Staff Report to the Planning Commission

Application Number: **08-0259**

Applicant: South County Housing Corporation

Project Description: Proposal to construct a 19 unit townhouse development for affordable homeownership with three Measure J units and a retaining wall over 3' in height within a front yard setback. Requires a Subdivision, a Residential Development Permit, a Coastal Permit, a Roadside/Roadway Exception, Soils Report Review, and Preliminary Grading Review to grade approximately 4,428 cubic yards including 1,000 cubic yards of cut, 1,000 cubic yards of fill, and 3,428 cubic yards of overexcavation and recompaction.

Re: New townhouse development at Canterbury Drive, Seacliff

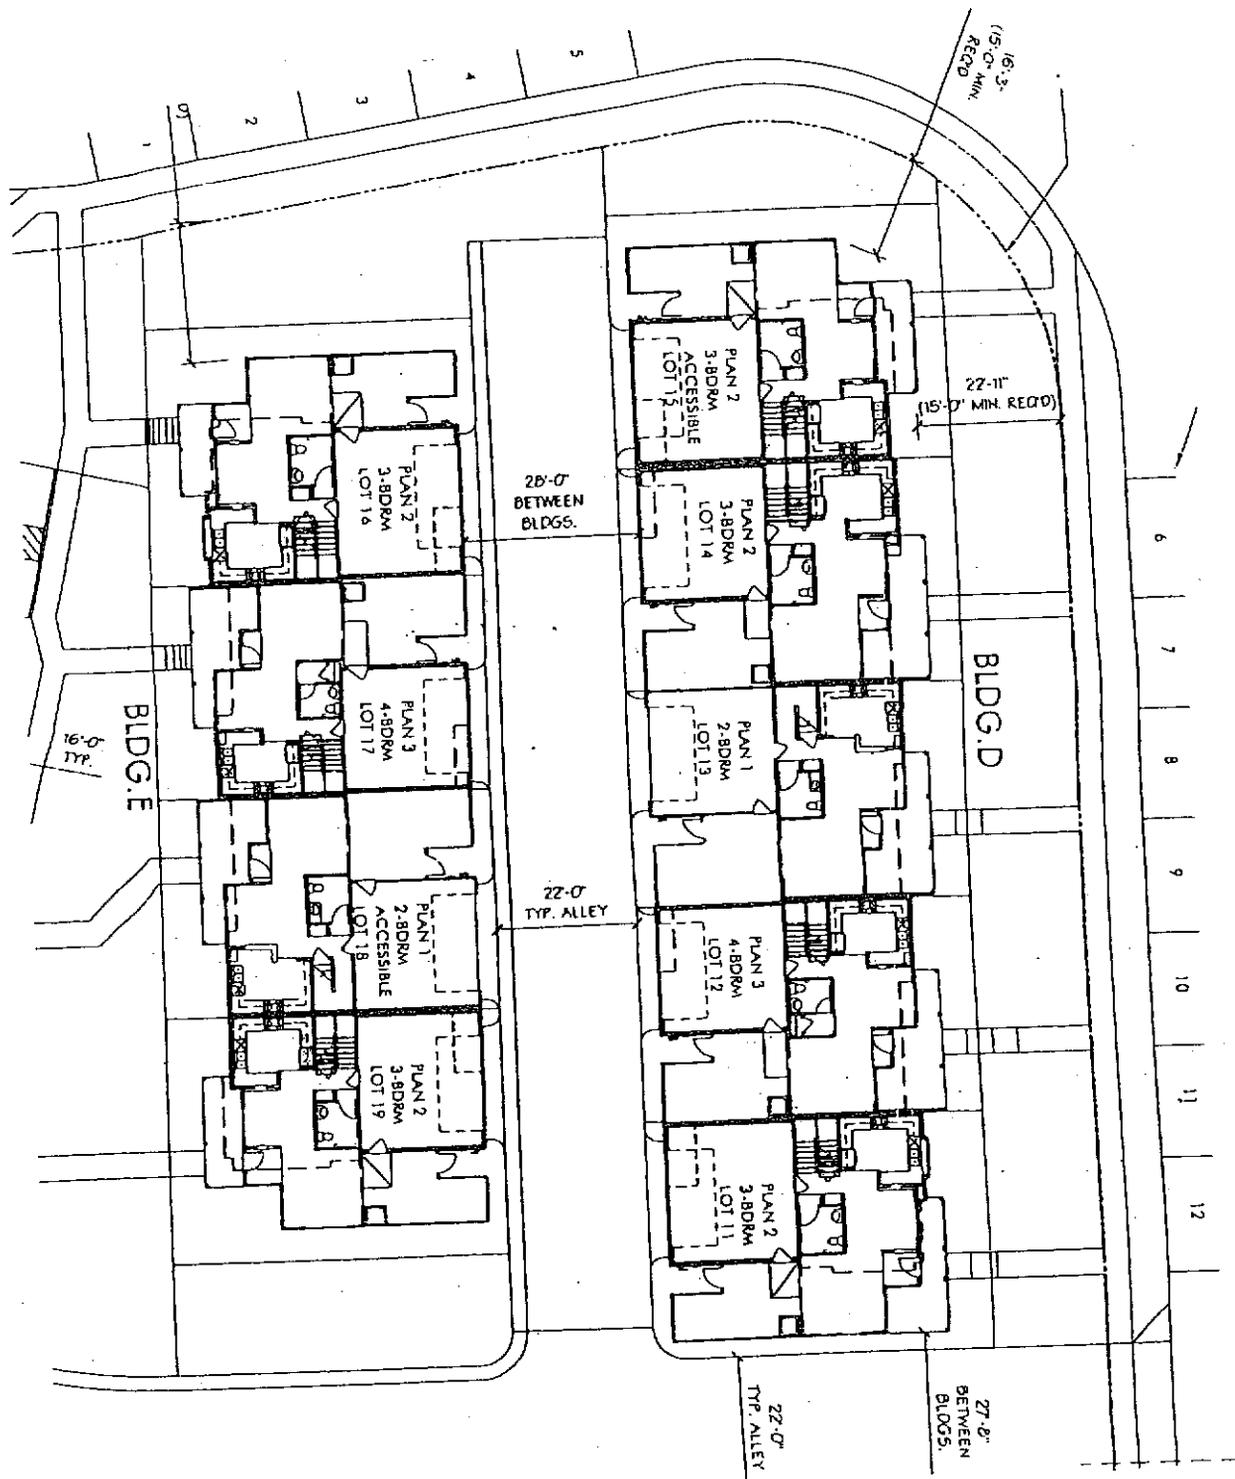
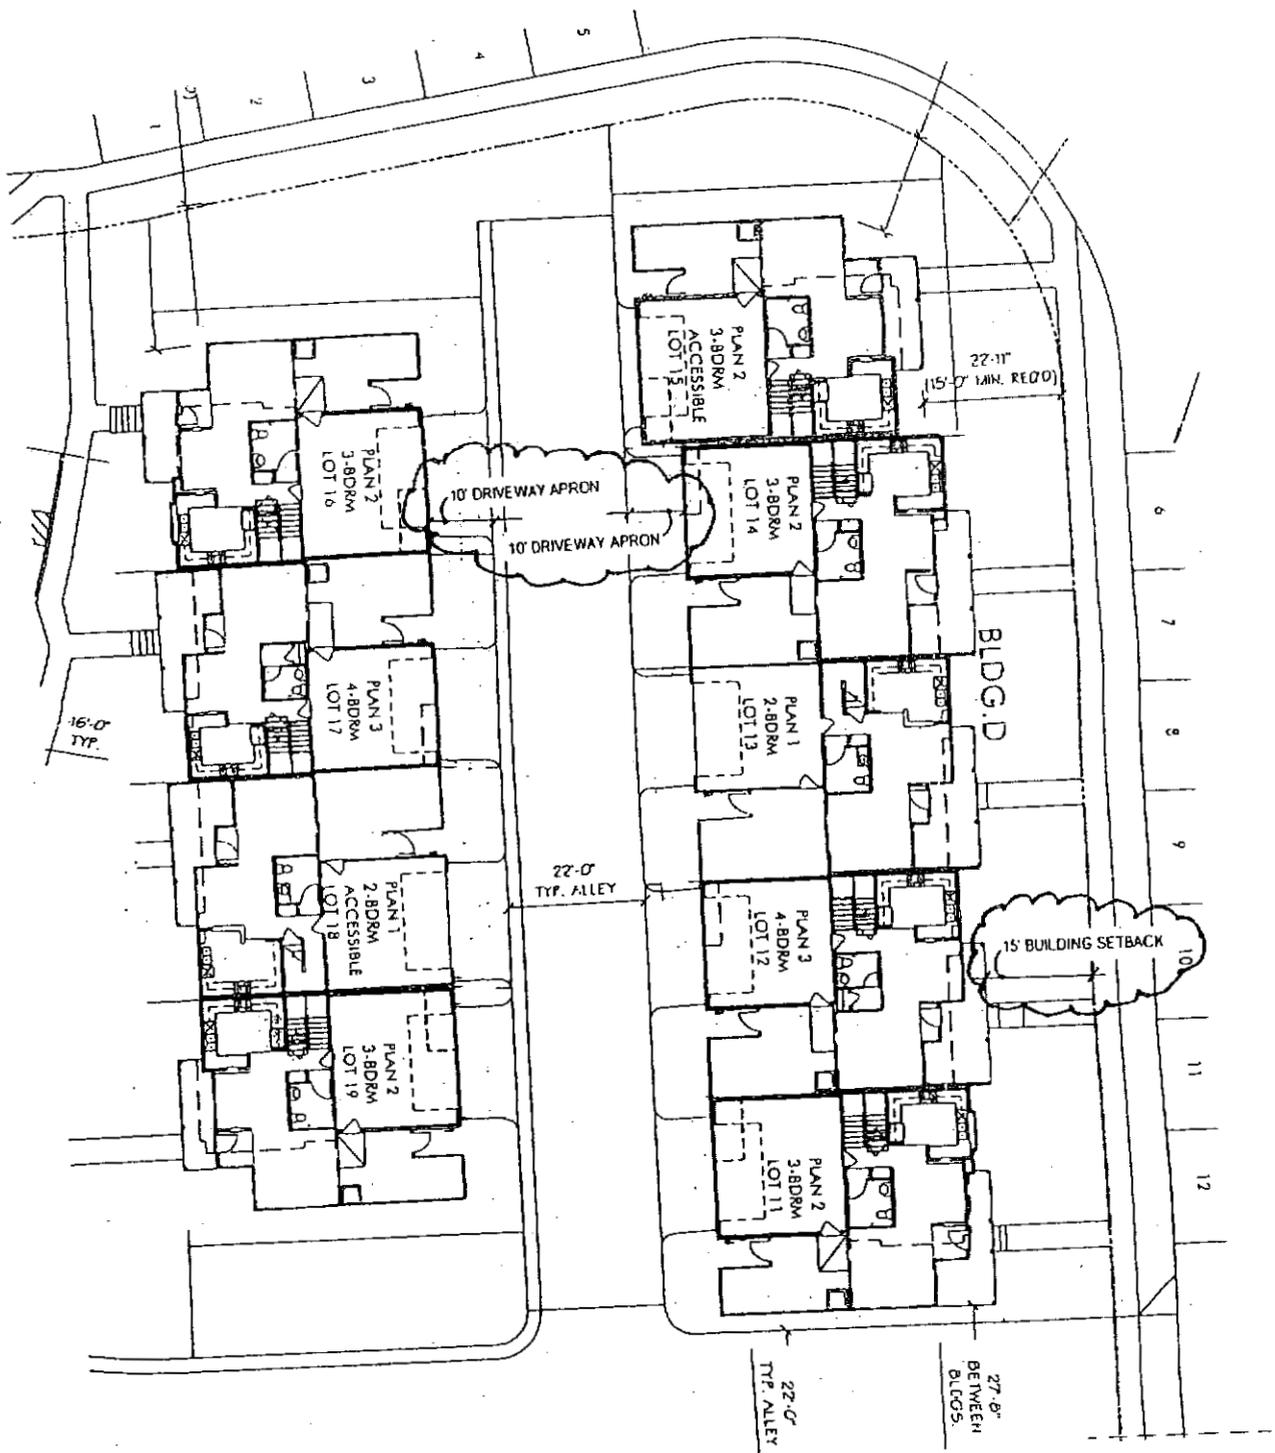
AS PROPOSED BY APPLICANT

AS SUGGESTED BY URBAN DESIGNER
